**THE HIGHLAND COUNCIL**  
**CAITHNESS, SUTHERLAND & EASTER ROSS**  
**PLANNING APPLICATIONS AND REVIEW COMMITTEE –**  
**18 December 2007**

**07/00543/OUTRC**

**Report by Area Planning and Building Standards Manager**

**NEW HOUSING AT DARROCH BRAE, ALNESS  
 HIGHLAND HOUSING ALLIANCE**

**SITE LAYOUT**

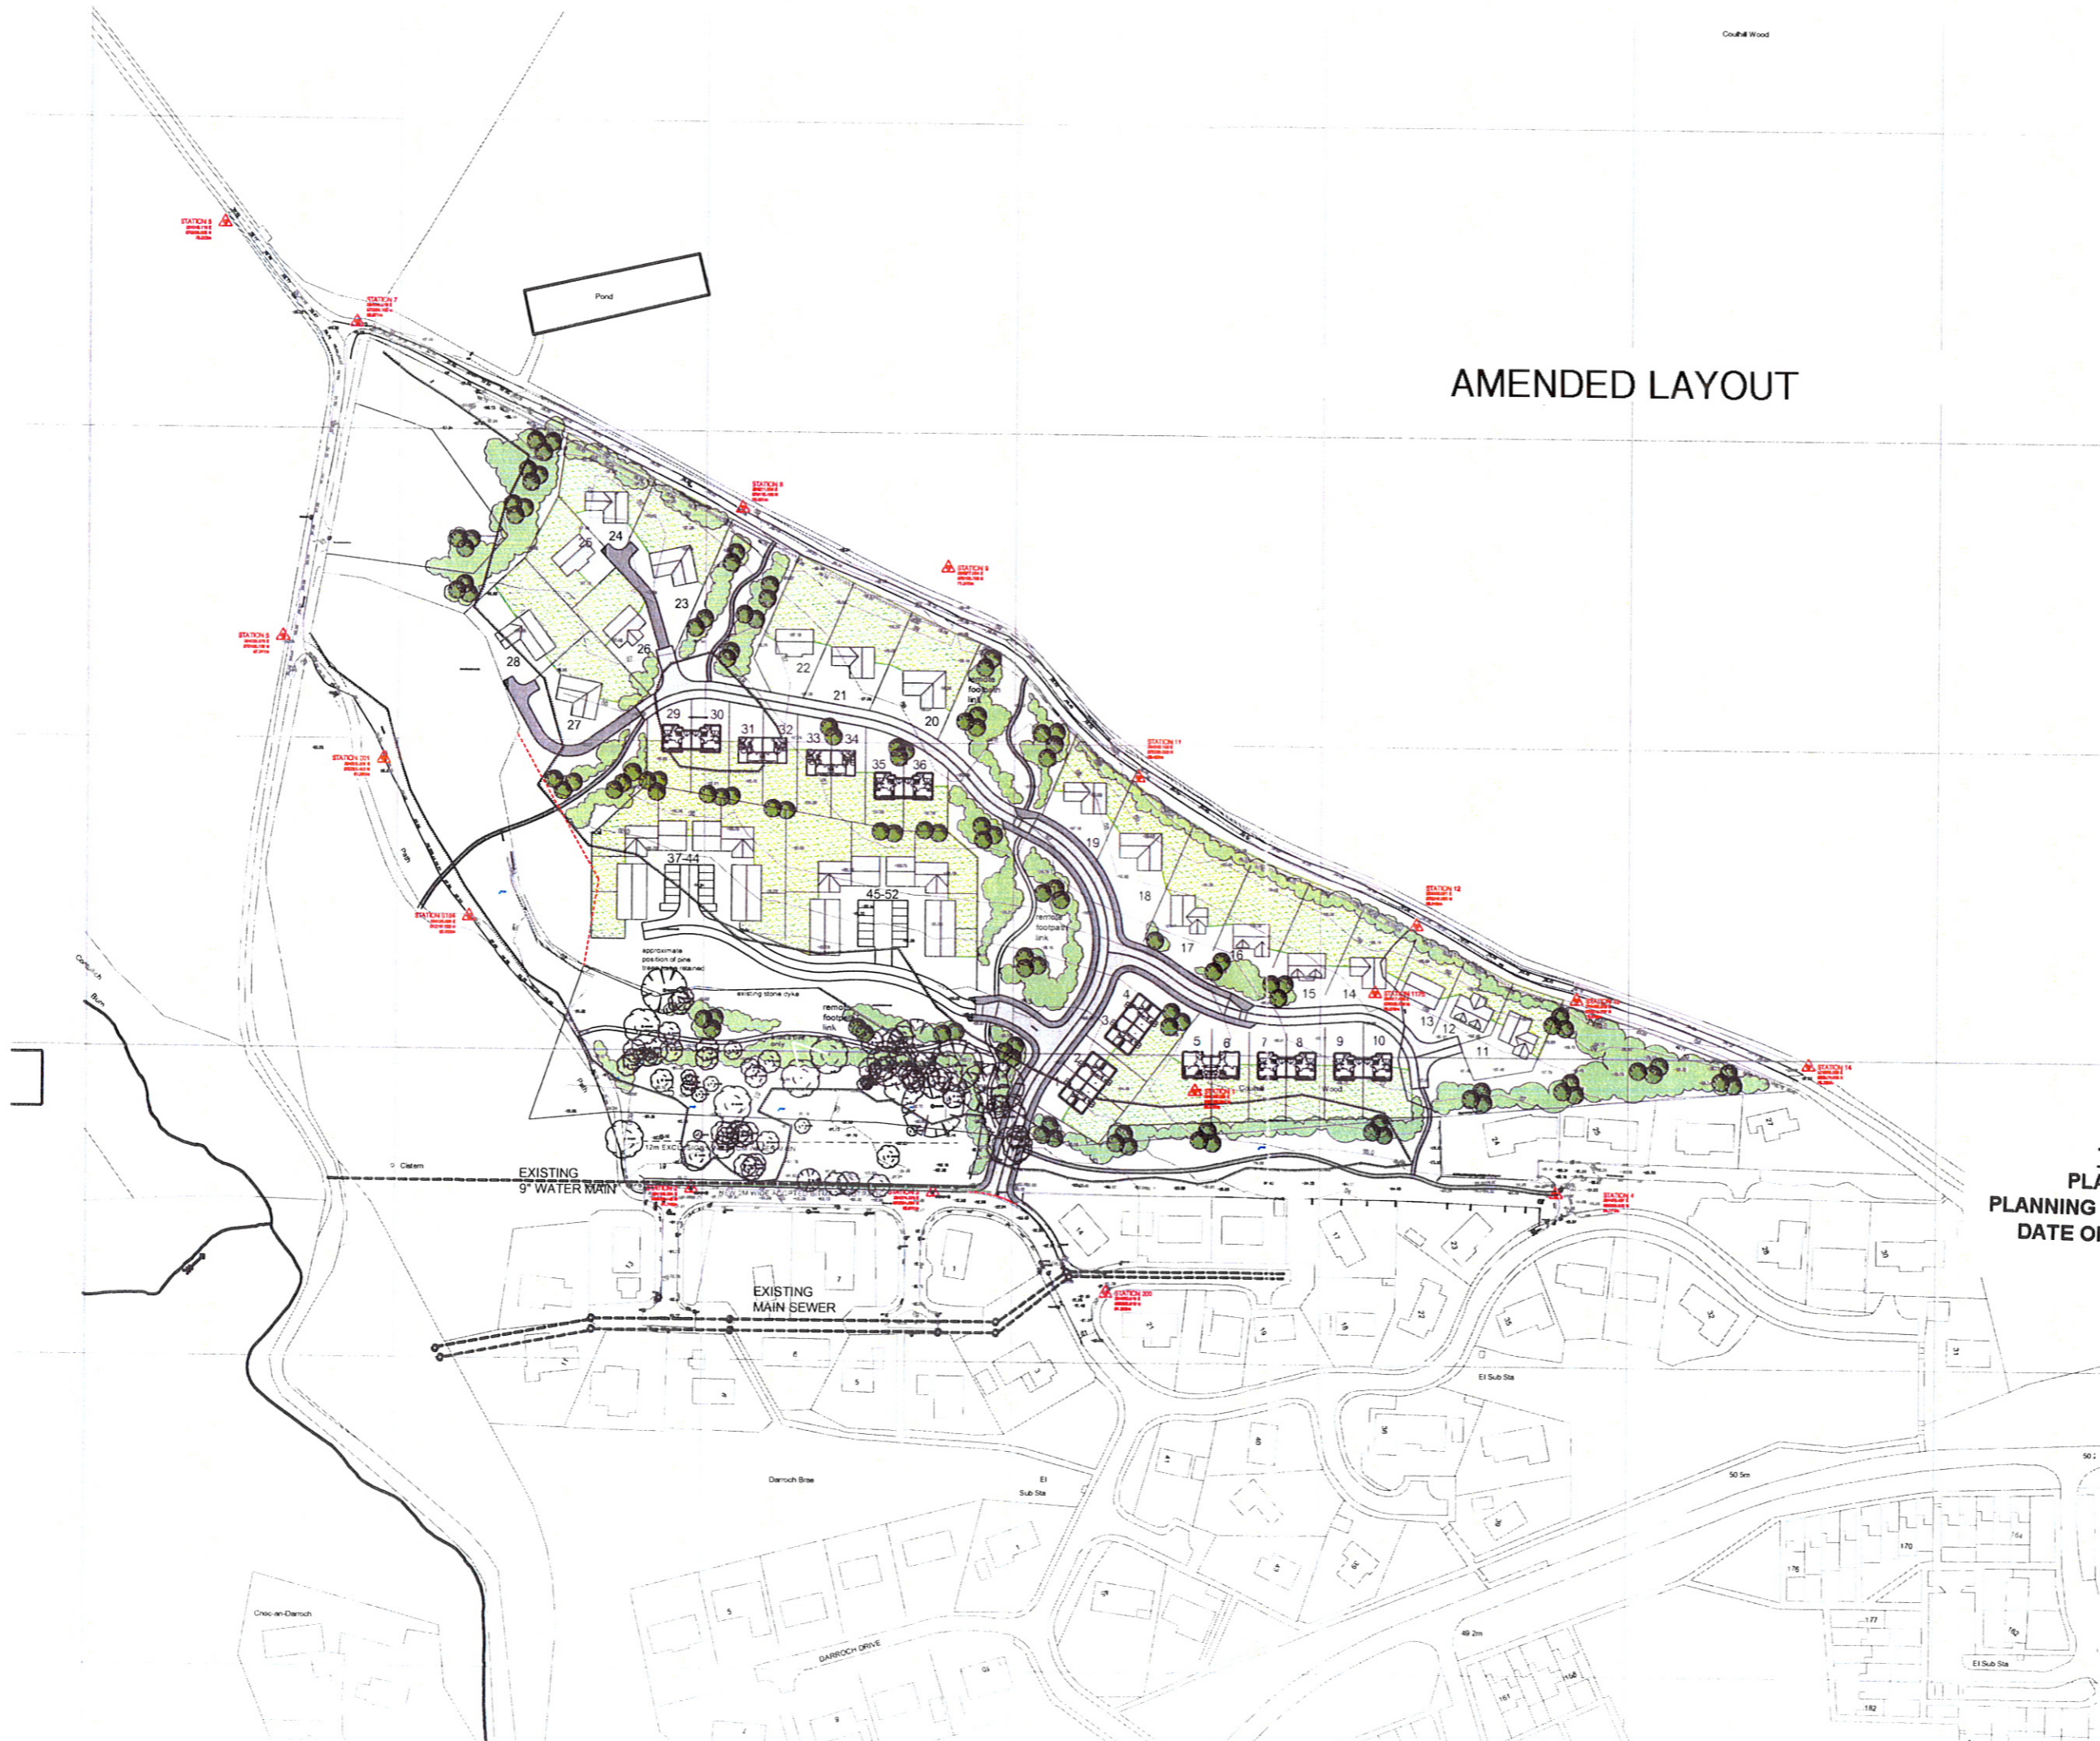
- The internal layout indicates that this will be the limit of development of such roads. This will need to be confirmed.
- The principle of a shared surface on the east leg is satisfactory; the principle of a shared surface on the two western legs will need further consideration due to the low density and relatively straight sections of road.

- There are link footpaths shown and responsibility for these will need to be identified. Link footpaths must join two adopted roads and those to be adopted will need to comply with Highland Council road guidelines.

- There are remote footpaths shown which would not normally be adopted. These terminate at the site boundary and no indication is given as to their termination.

- It is noted that SuDS facilities are outwith the site boundary and that no access arrangements are shown.
- The alignment of the current Darroch Brae is adequate to support this development. There are however concerns over the structure of the

- The levels shown on the access track to the north of the site show that it undulates leaving low points. This track will attract water from the land above as well as on the track itself and will discharge into the houses below at the low points. A system will need to be put into place to prevent this and deal with water.

4.2.3 **Forestry Officer:** Following a meeting on-site with the applicants' agents, there are no objections to the proposals. The main concern relates to the retention of the more intact group of mature trees to the north of the five proposed plots adjacent to the existing road. While the indicative layout has been amended to try and account for this, the proposed affordable housing is still close to the existing trees which are likely to cause shading issues being located immediately to the south. The agents have confirmed that these trees will be accurately plotted and the layout amended, if necessary, to ensure their retention. Given that this is an outline application, there are no objections subject to appropriate conditions being attached as advised. This includes any detailed application being supported by a Tree Constraints Plan which will inform the layout and ultimately dictate the capacity of the site. Once the layout has been agreed, a Tree Protection Plan and Landscaping Plan must be submitted for approval, prior to any detailed planning consent being issued.

- Houses shall have a designed frontage to the service road and shall reflect the scale and density of adjoining development. For the avoidance of doubt, the houses on plots 1 - 12 shall be single storey or one and a half storeys maximum, designed to ensure that there are no windows at upper floor level overlooking the established properties at Darroch Brae.
